Work Order ID 79666

Item Name: Crosstube Assembly, Mid Aft

DART AEROSPACE LTD HAWKESBURY, ONTARIO, CANADA	
DRAWING NO. D206-667-247	REV. A
TITLE CROSSTUBE ASS'Y (206L MID AFT)	SHEET 1 OF 4
SCALE NTS

DRAWING NO. D206-667-247	TITLE CROSSTUBE ASS'Y (206L MID AFT)	REV. A	<b>DART AEROSPACE LTD ENGINEERING ORDER</b>		D.E.O. NO. D206-667-247-A-1	SHEET NO. SHEET 1 OF 1	SCALE NTS
DRAWN 92	CHECKED ASS	MFG. APPR. KTB	APPROVED JMD		DE APPR. H		
DATE 11.07.15	DATE 11.07.20	DATE 11.07.21	DATE 11/07/21		DATE 11.07.21

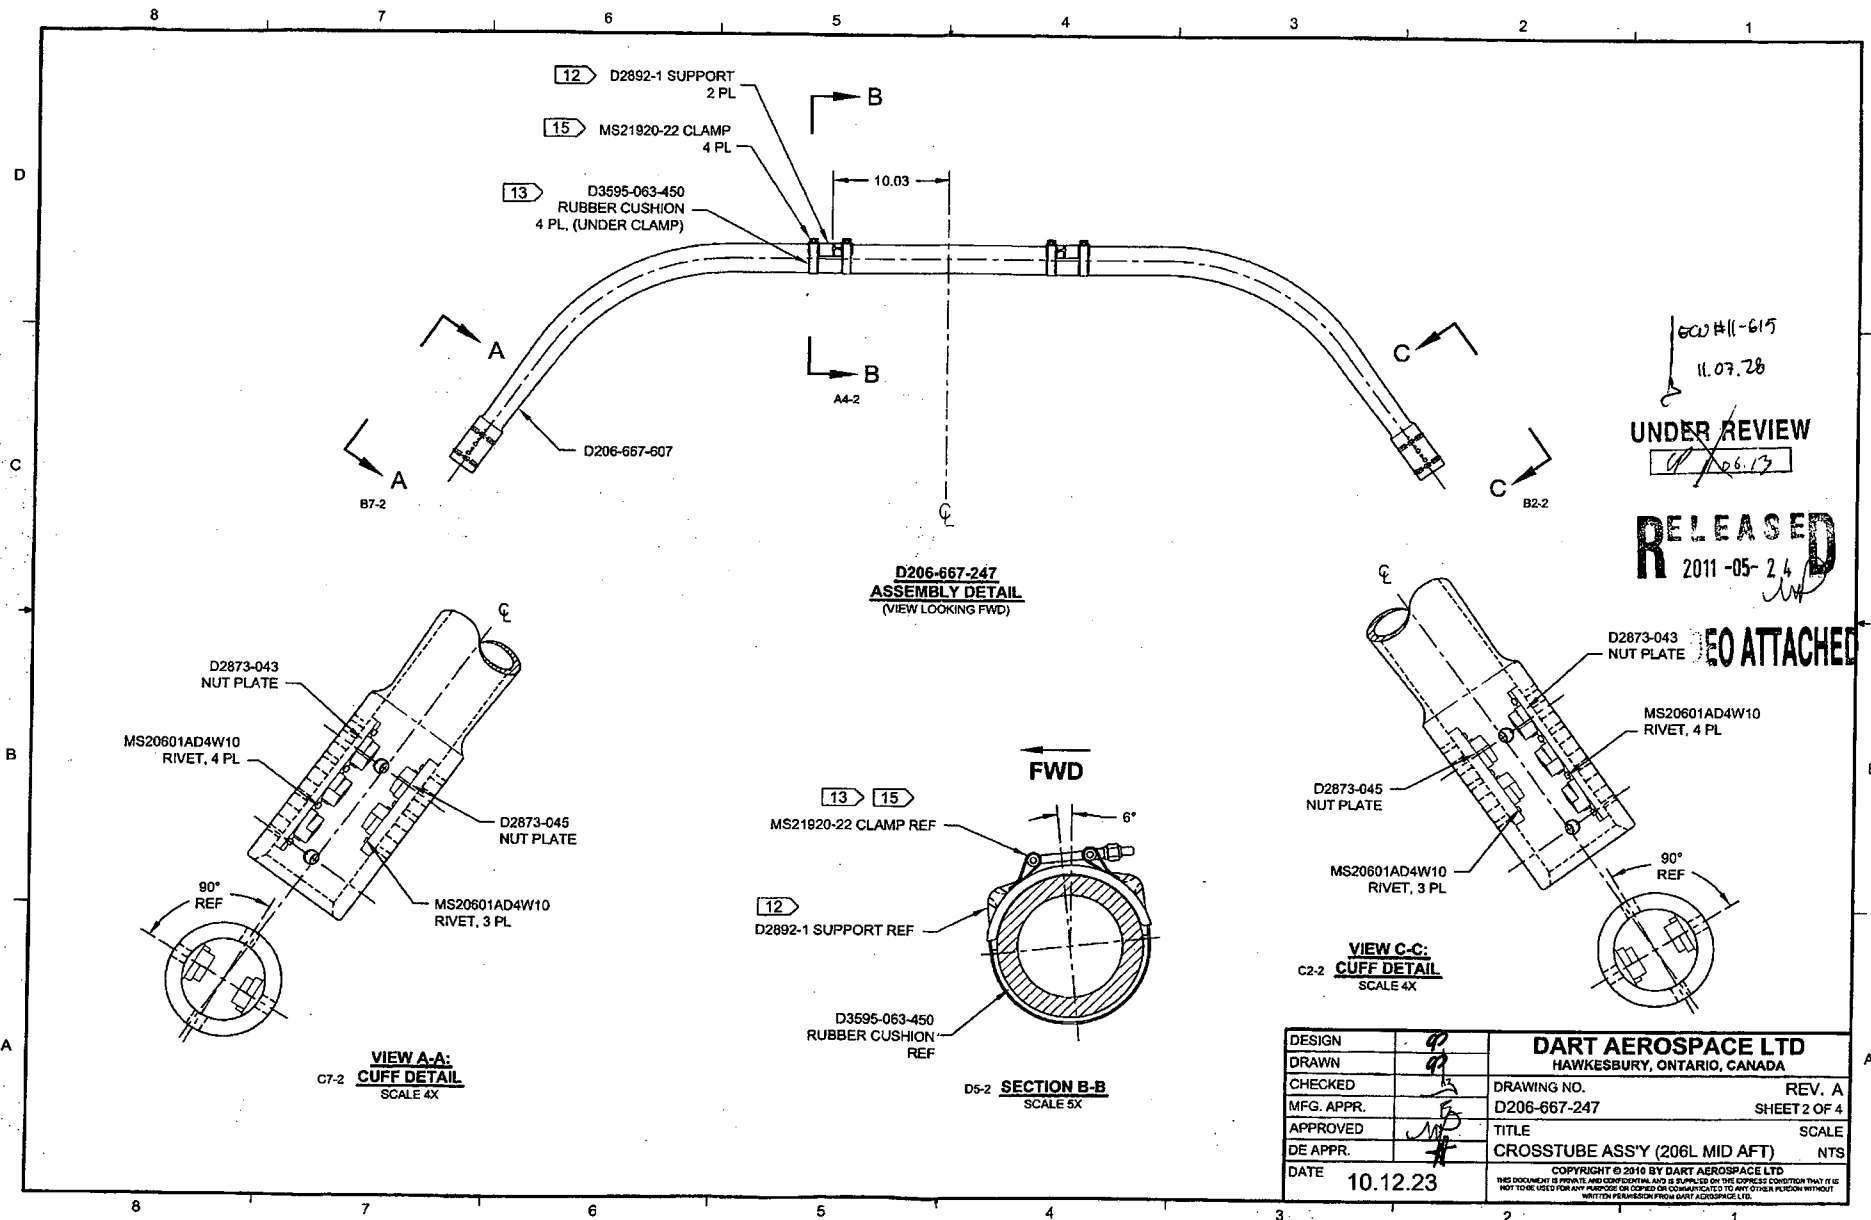
**PURPOSE:**

REPLACE MAGNOBOND WITH PROSEAL.

NOTE 12 & 15, SHEET 1 IS AMENDED AS FOLLOWS:

Item	Qty -247	Part Number	Description
9	A/R	PROSEAL 890 B-2	SEALANT, AMS-S-8802 CLASS B-2

- 12) TO INSTALL D2892-1 SUPPORT: ABRASE MATING SURFACE OF SUPPORT AND CROSSTUBE WITH 180-GRIT SANDPAPER AND REMOVE RESIDUE WITH MEK (OR EQUIVALENT). APPLY A 0.04" TO 0.07" THICK LAYER OF PROSEAL 890 CLASS B-2 (OR AMS-S-8802 CLASS B-2) SEALANT TO MATING SURFACE OF SUPPORT.
- 15) TORQUE CLAMPS 80 TO 100 IN-LB. ENSURE AT LEAST 1.5 THREADS SHOWING IN SAFETY AND THAT NUT HAS NOT BOTTOMED-OUT AFTER TORQUING. **PRIOR TO PACKAGING, RE-CHECK TORQUE ON CLAMPS AFTER PROSEAL 890 SEALANT HAS CURED FOR 72 HOURS.**
